**RUSSIAN FEDERATION**  
**MINISTRY OF TRANSPORT OF RUSSIAN FEDERATION**  
**FEDERAL AIR TRANSPORT AGENCY**  
**AIRWORTHINESS DIRECTIVE**

No. 2021-AHCAT-CK-05

Applicability – ANSAT helicopters (model ANSAT-GC)

**TECHNICAL DECISION No. 1/144-2021-KB3**

ANNEX 5

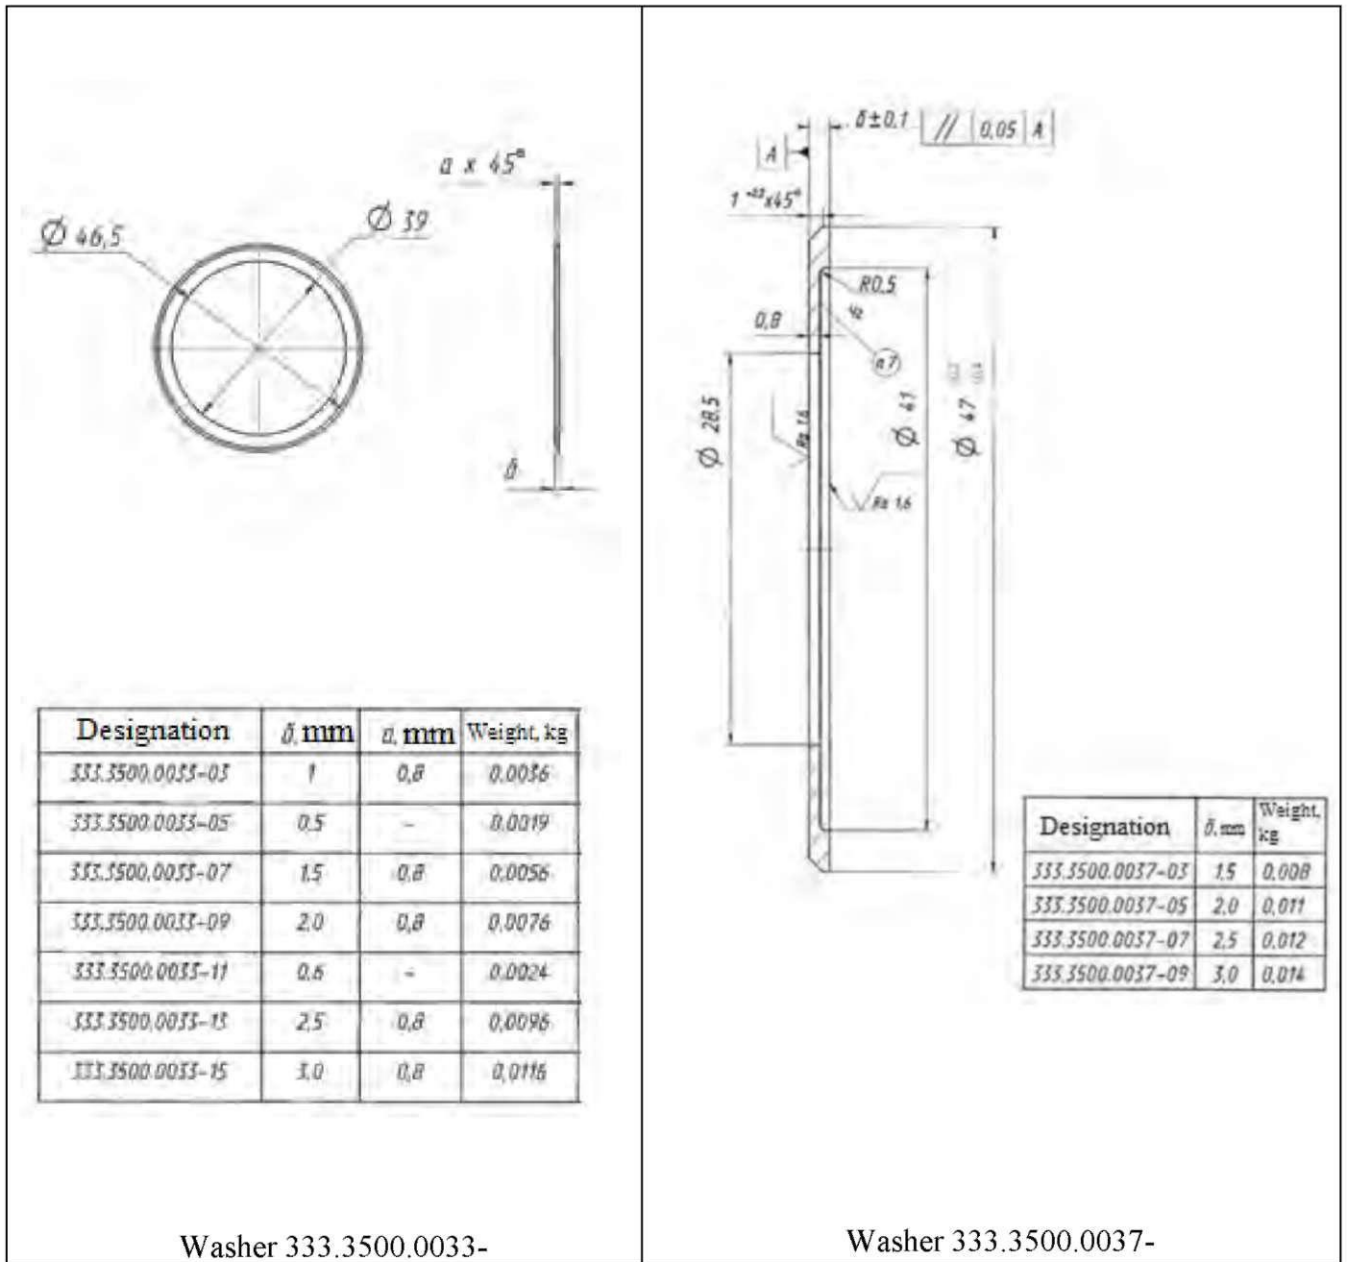
At that make an entry in column “Remarks” in section 2 “Delivery set” of certificate 333.3520.1000-ПC of the number of actually installed washer 333.3500.0033- and 333.3500.0037- (see Annex 5), having measured their thicknesses beforehand.
